LIFFEY CYCLE ROUTE PROJECT

Submission
From
Lowstrand Properties Ltd
To
Dublin City Council

May 2019

6.7 Dublin Cycling Campaign

View across road from outer edge of footpath, and from inner edge.

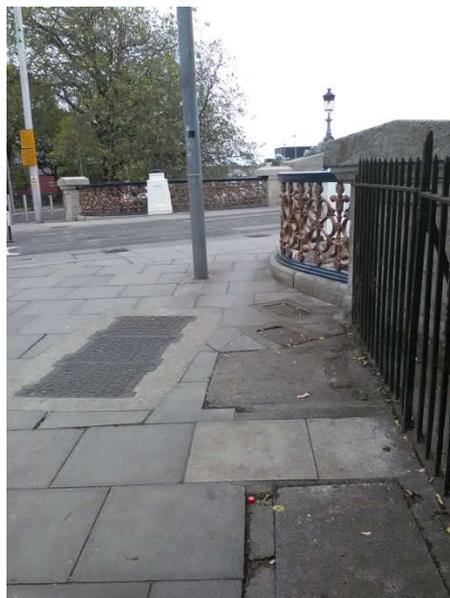
People with impaired vision walking from Parkgate Street to Wolfe Tone Quay face dished kerbs with no tactile paving installed, and no pedestrian lights, on the left hand side of the road, (if you have your back to the Park), and on the right hand side, they are expected to cross the road at the junction with the “Luas only” bridge, which has no kerbs, no tactile paving, and no pedestrian signals – just a white track painted onto the road surface, with the symbol for the Luas painted onto it.

This white track may be visible for people with impaired vision who are walking out near the edge of the road (very unusual for them to do so) but if they are walking

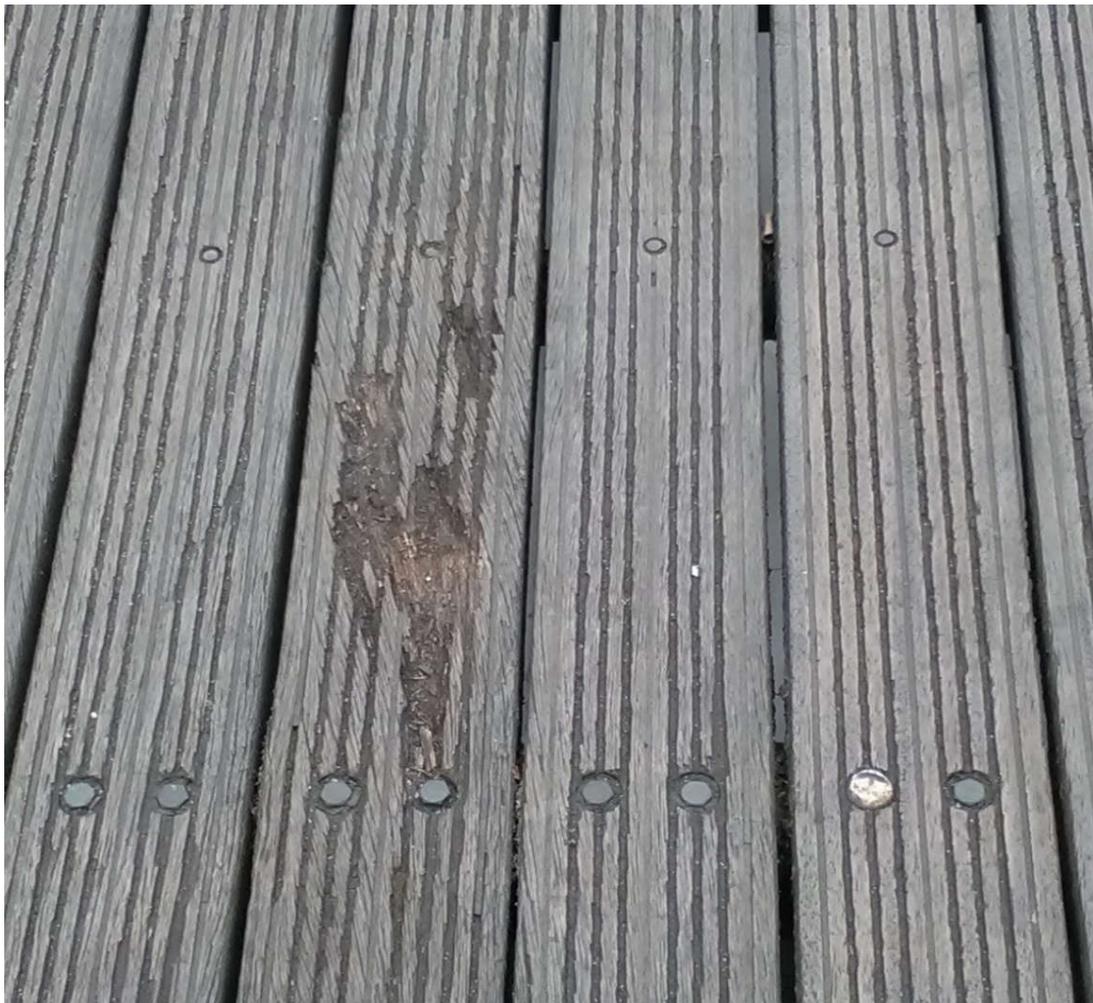
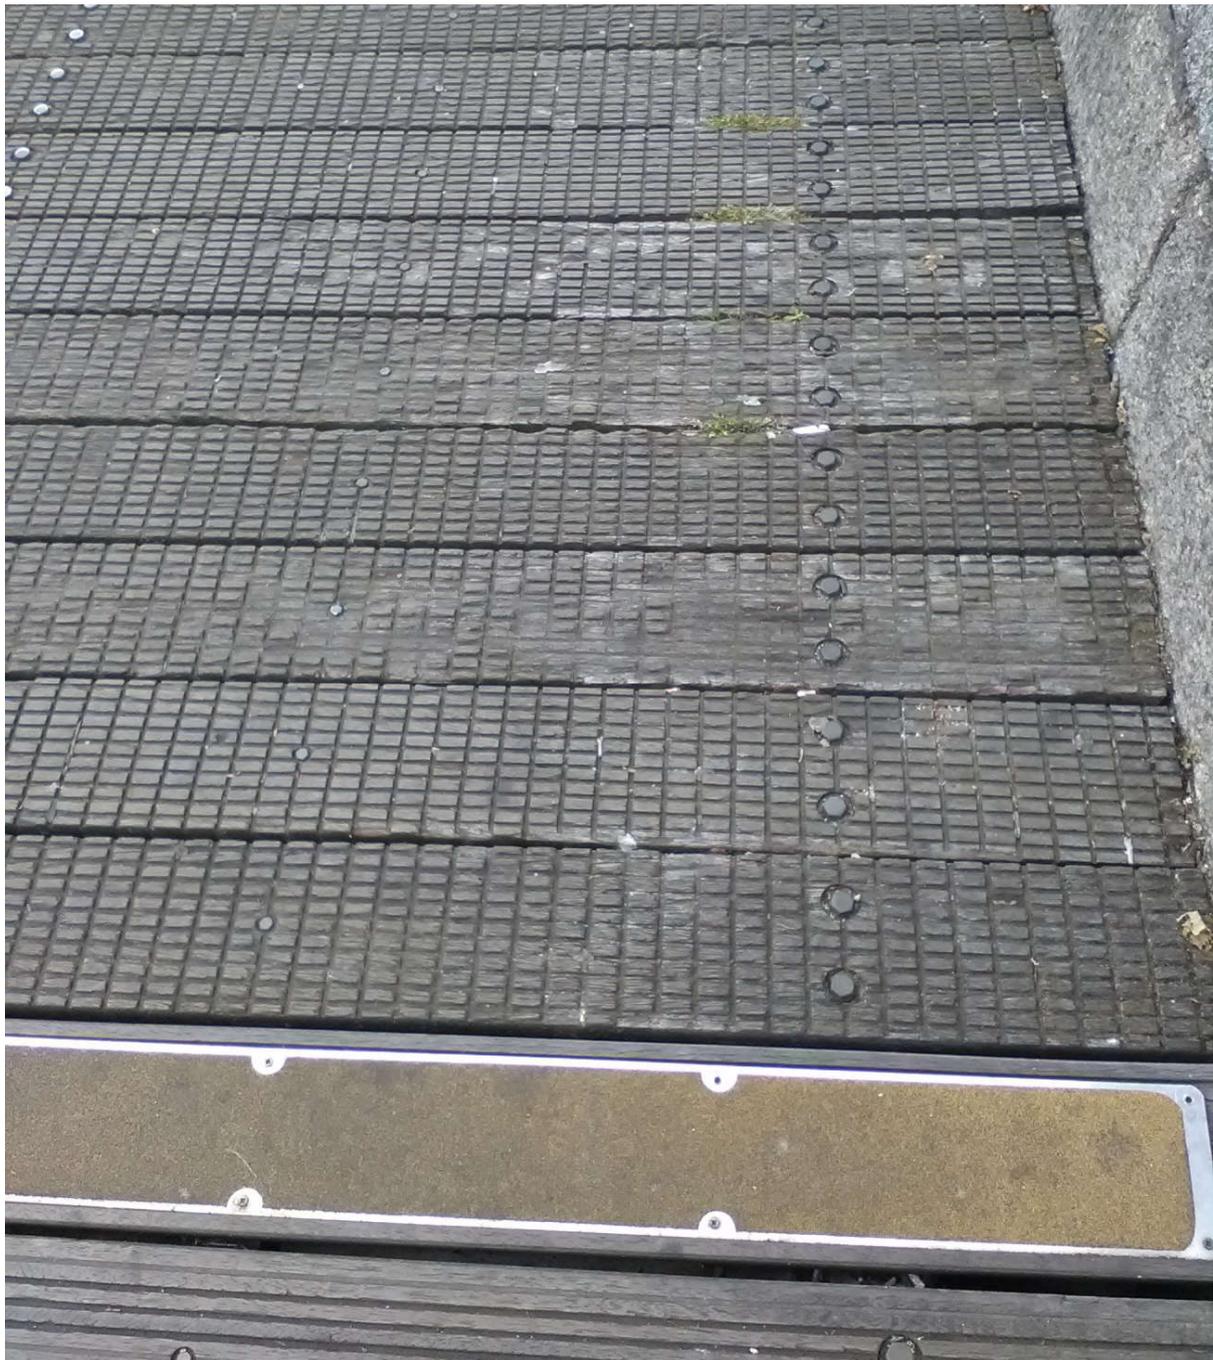
NCBI has been assured that the material of the new boardwalks will be carefully selected. We would like to draw DCC's attention to the damage and wear to the existing boardwalks (see photographs below).

We also hope that the new boardwalks will meet the requirements for slip-resistance, and that the surface of the existing boardwalks will be improved to match.

Photo of Boardwalk: some damage and wear to the current surface. How long has it been in place? As wood does not last forever, are there plans in place to replace it when it wears out, and is there a budget for this? The initial cost of adding boardwalks is not a once-off cost. A maintenance and / or replacement budget also needs to be set aside.

Below: mooring hooks attached to the footpath, a serious trip hazard for people with impaired vision – but an essential feature in a docking area.

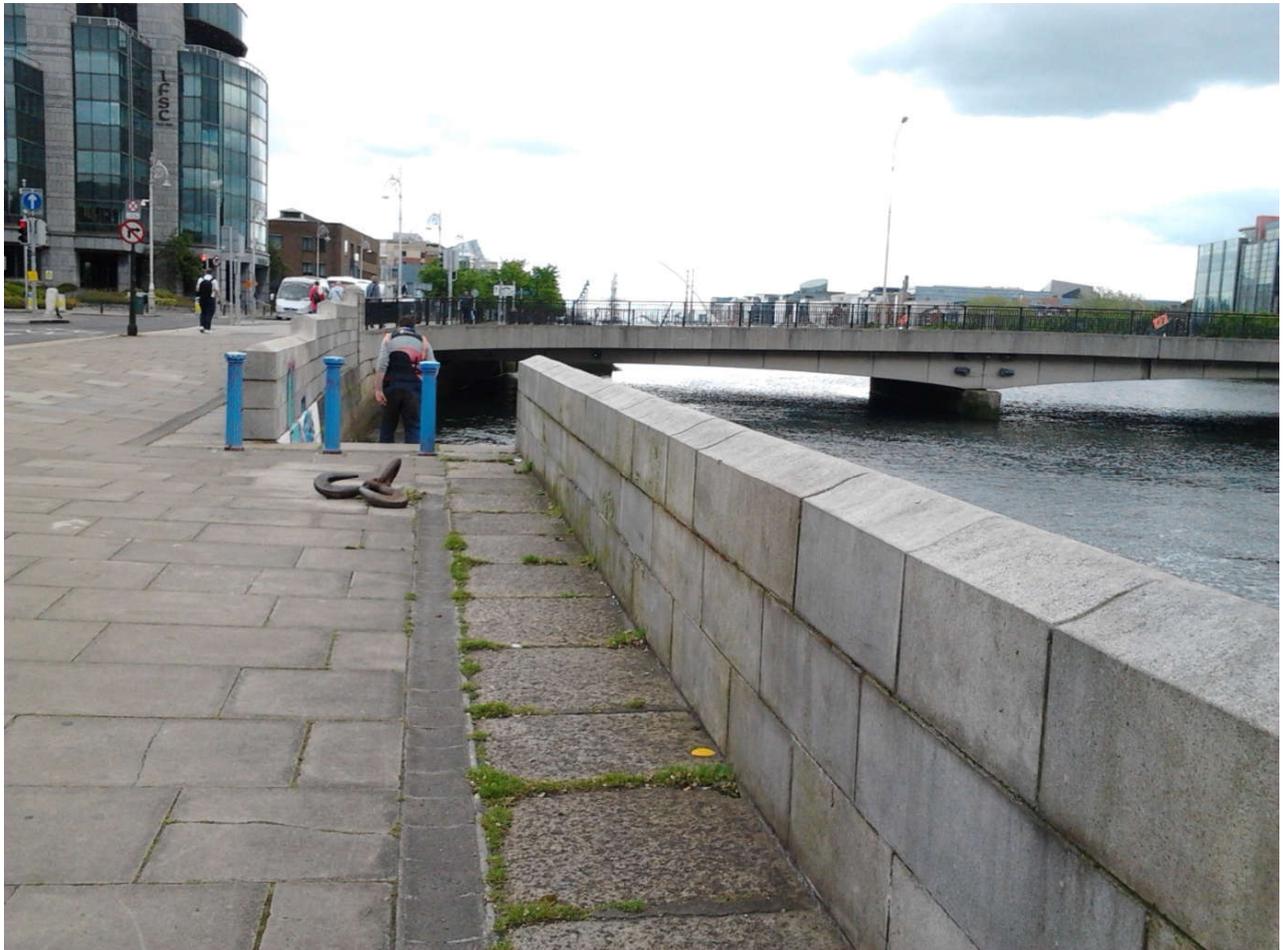
Pedestrians with impaired vision walking along the route, as it goes through Docklands, will also find themselves facing unusual hazards – which are necessary parts of that environment.

There is also a steep flight of steps down to the water, just after these hooks. Obviously access is necessary, but a person with impaired vision could fall down these steps, as there is nothing to warn of them.

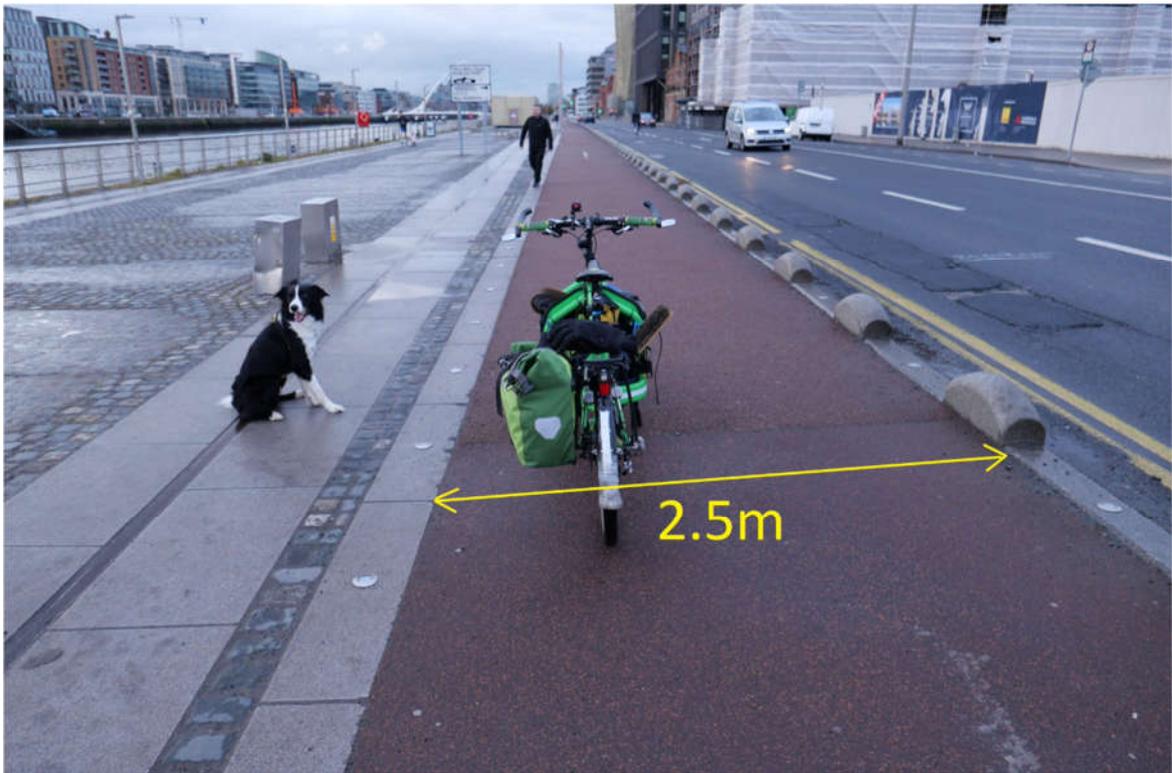
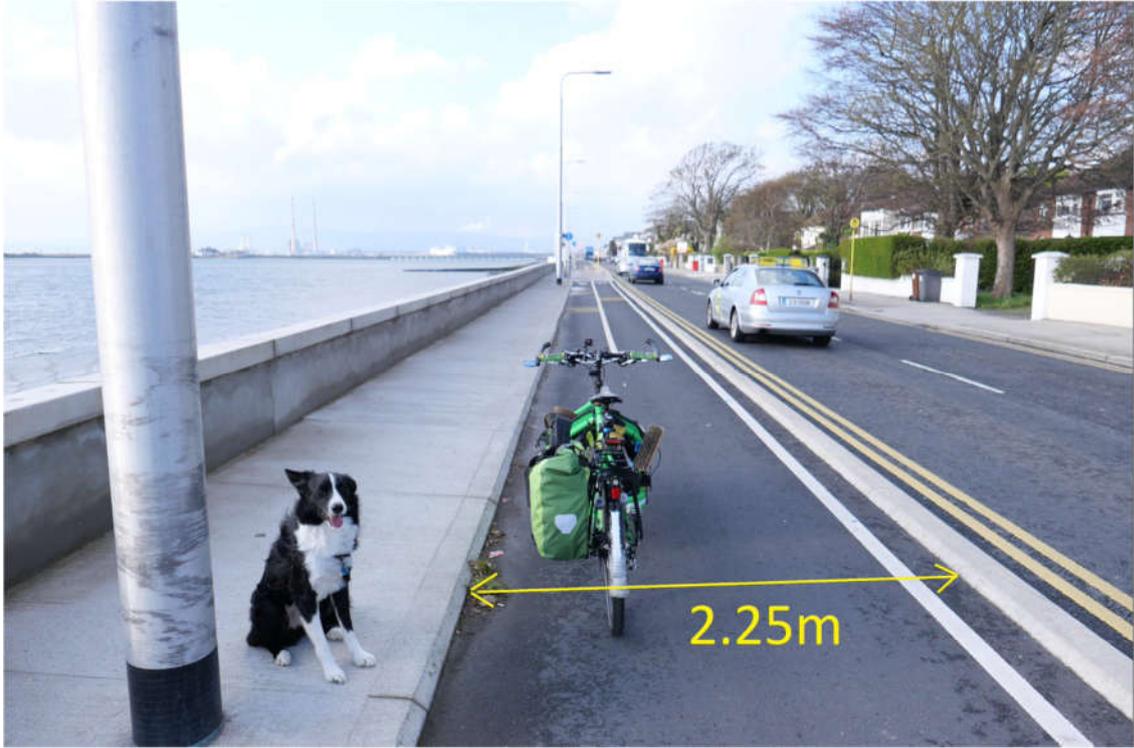
See the attached photos. The first one is from the S2S north at its narrowest point, which is 2.25 meters wide. Granted, this is a 2-way cycle-lane, but it still feels awfully narrow when trying to overtake someone (even if there's no-one coming from the opposite direction). The numbers on the S2S north are far less than on the Liffey quays. I did a couple of counts of the S2S north last year and there were 420 people on bikes during morning peak hours and 410 during evening peak hours. This is far less than the current 900 at peak hours on the Liffey Quays.

At peak hours on the S2S north, the narrowest points result in bunching of bikes as people slow and try to overtake. However, the narrow points don't last very long, and when the lane widens open up again it allows much easier and frequent passes. This won't be the case on the proposed Liffey cycle-route which appears to be at maximum 2 meters for almost the entire length (there is 3m wide segment at the start of the eastern end of the south section).

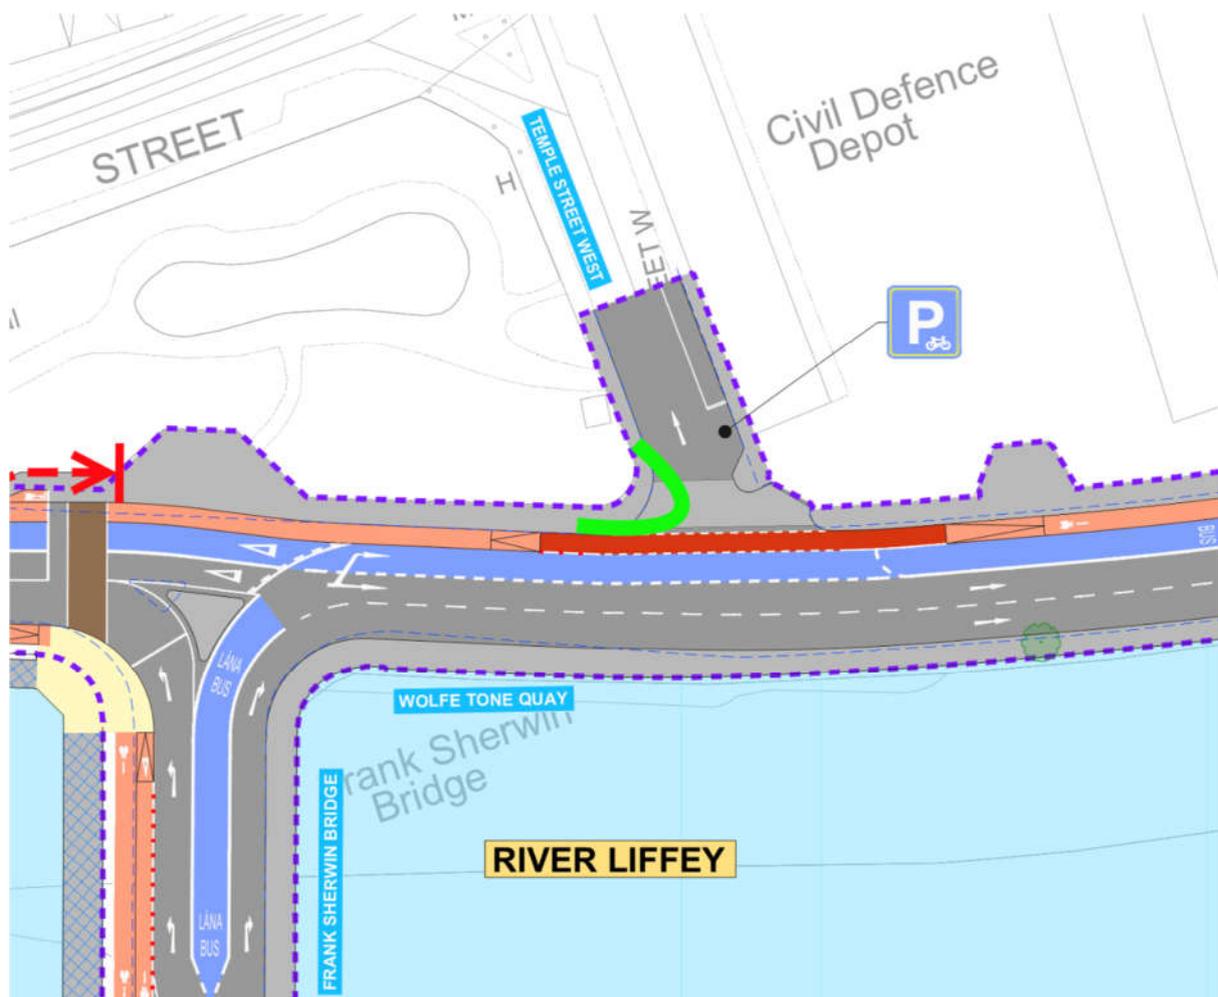
"The wide junction when accessing Temple Street West from Wolfe Tone Quay is a hazard to cyclists and pedestrians. The access is far wider than is necessary for a quiet one way street, and it

allows vehicles to turn left onto Temple Street West at speed due to the wide width. This makes it dangerous for cyclist travelling east and for pedestrians trying to cross this junction.

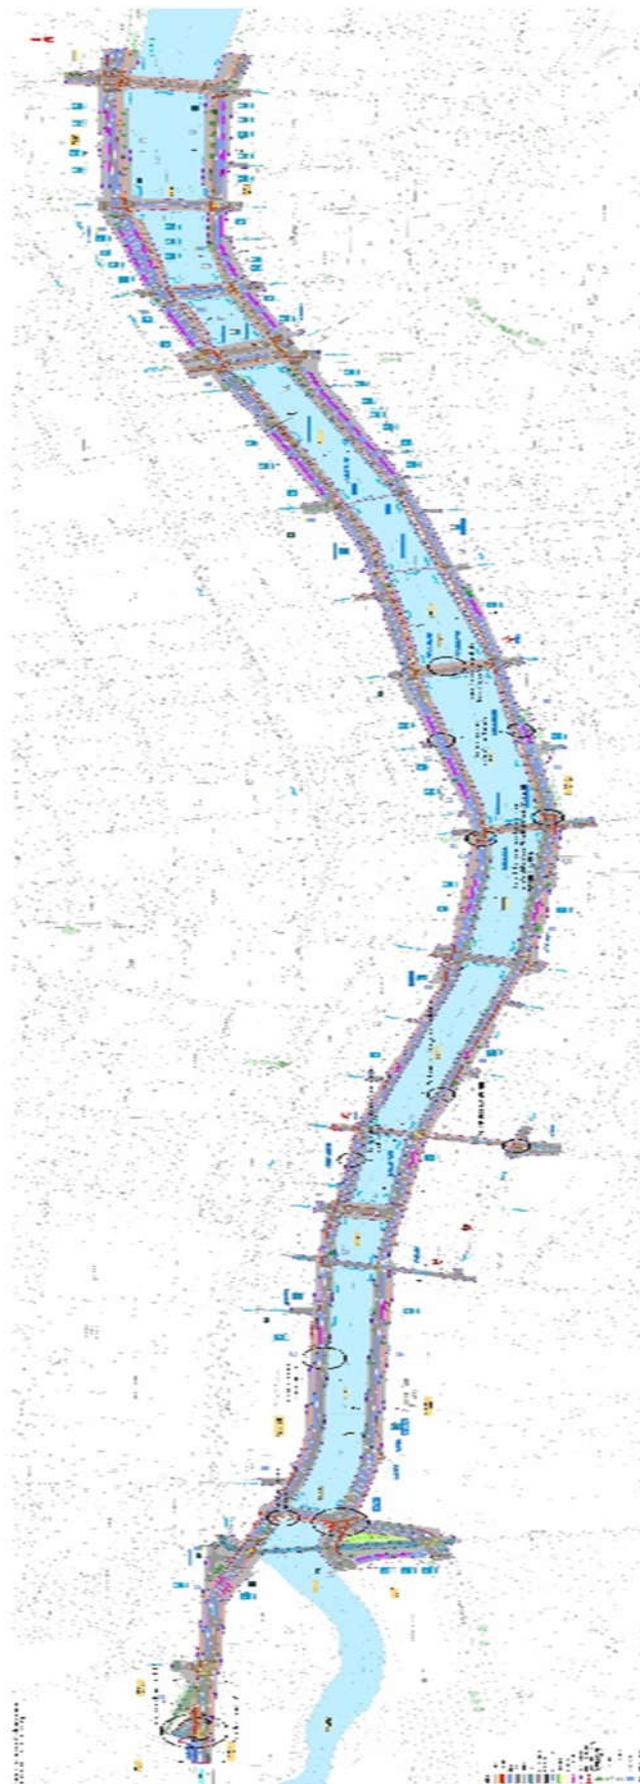
Proper, protected junctions for cycling, providing segregation between cars and bicycles should be installed at all junctions where feasible. On all four arms of junctions, pedestrian crossing should be provided. Similarly, the design of the route should use Dutch design principles to enable cycling turns in all directions (including right turns) to be made easily and safely by cyclists of all ages and abilities.

Proper segregation with a proper curb is needed along the entire length of the route on both quays, otherwise the route will be blocked by parked cars and feel less safe for cyclists. I would feel less safe without a proper curb with a decent vertical height and horizontal width providing segregation (similar to the proposed 1.0 metre wide curb at the Custom House). The aim of the project, as stated in the report, is to cater for cyclists of all abilities; would parents of primary school children feel safe cycling with their children along this route if proper kerb segregation is not provided along the route's entire length? Where this poses issues at pinch points, general traffic lanes should be reduced in width or removed.
